PRELIMINARY PLAT FOR
 VOLCANO MESA AT THE TRAILS
 LOTS 1-72 AND TRACTS A-G
 SEPTEMBER 2021

**RE: WAIVER IDO / Volcano Mesa at The Trails
PR-2021-005717**

Project: Volcano Mesa at the Trails Agenda Item No: 6

HEARING DATE: 8/2/23 -- **AGENDA ITEM:** DFT #6

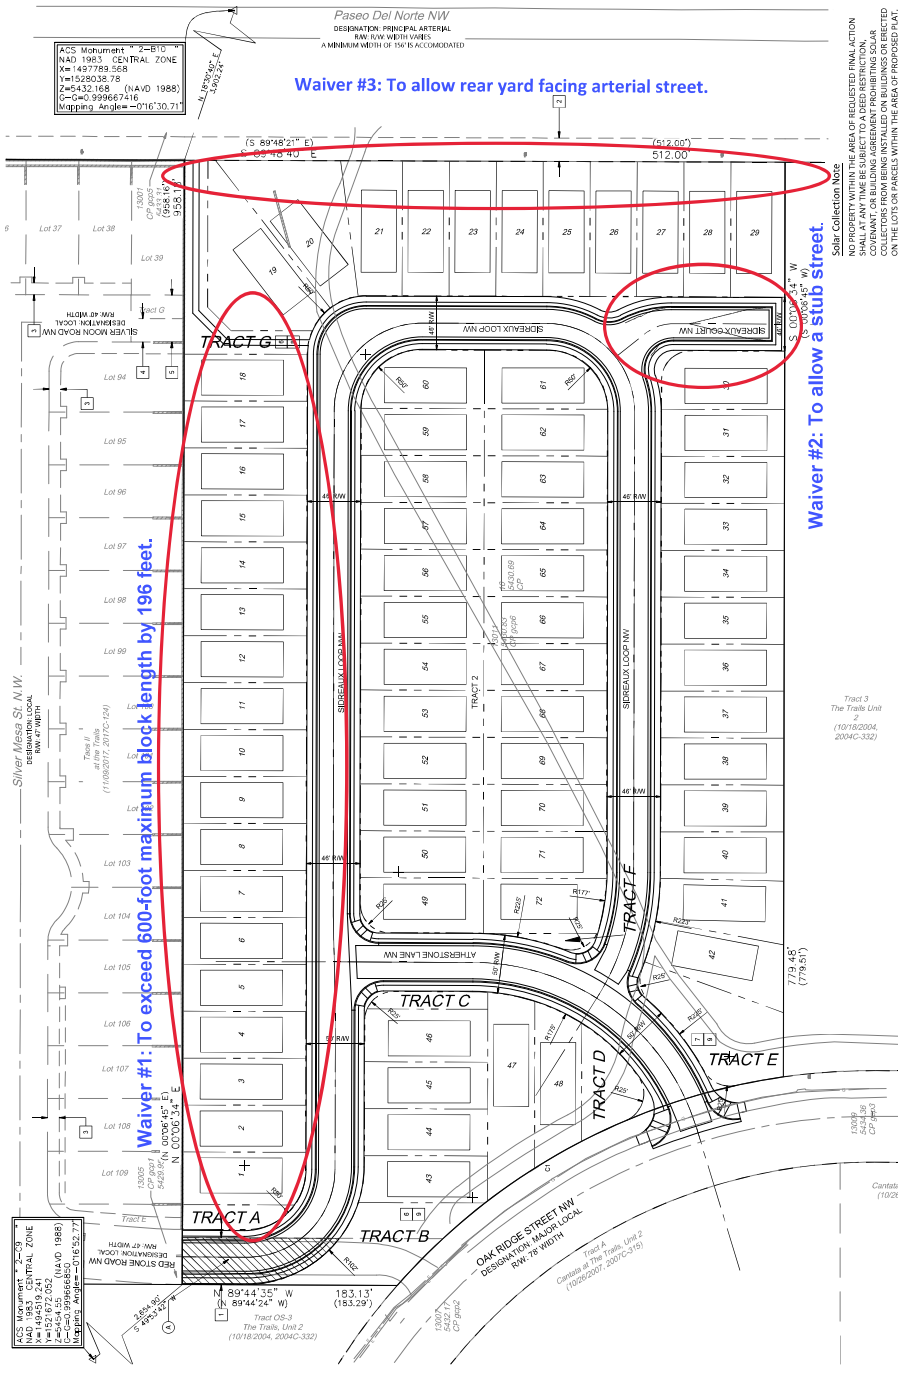
Waiver #1: To exceed 600-foot maximum block length by 196 feet.

Waiver #3: To allow rear yard facing arterial street.

Waiver #2: To allow a stub section.

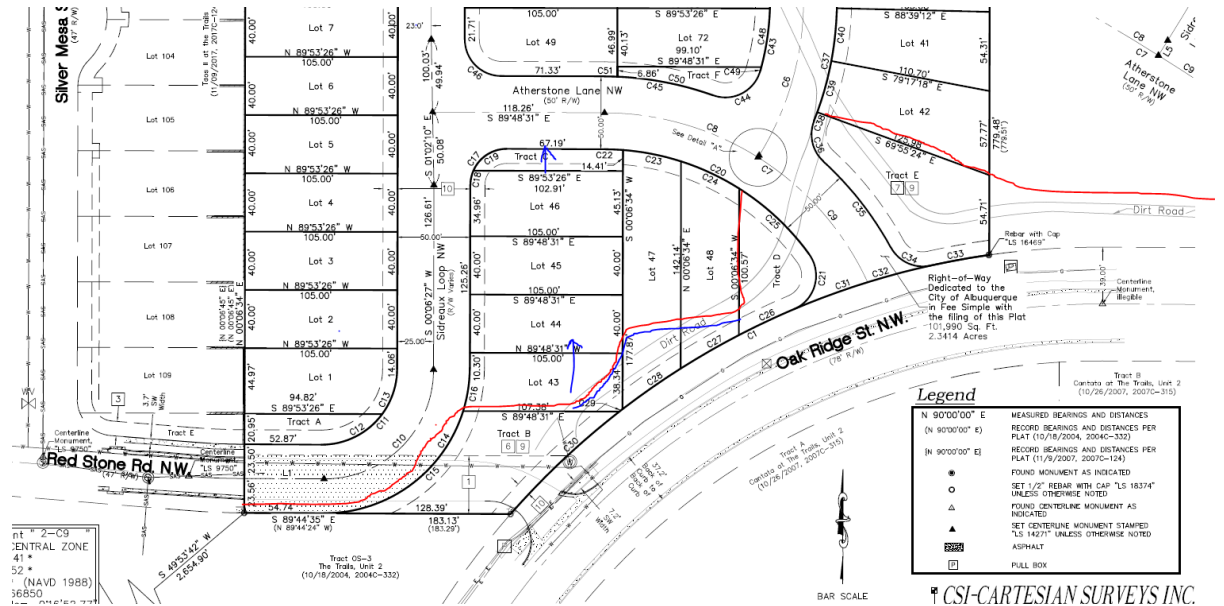
- Recent planning work has identified the value of continuing the east-west linear park and trail system that is well established through the Trails subdivisions to the west. With modifications to only three lots, this subdivision can continue this amenity that enhances the subdivision you are creating and provides east-west connectivity for the community in this area. (The red line below points out the open space that can be part of this system.) The connected open space maintains the natural desert ecosystem through this area. Could lots 43 through 46 be moved north to allow for an open space band along the north side of Oakridge? Could lots 47 and 48 be reduced from their unusually long dimension to provide the connection to Tract D? (The blue lines indicate recommended lot changes.)
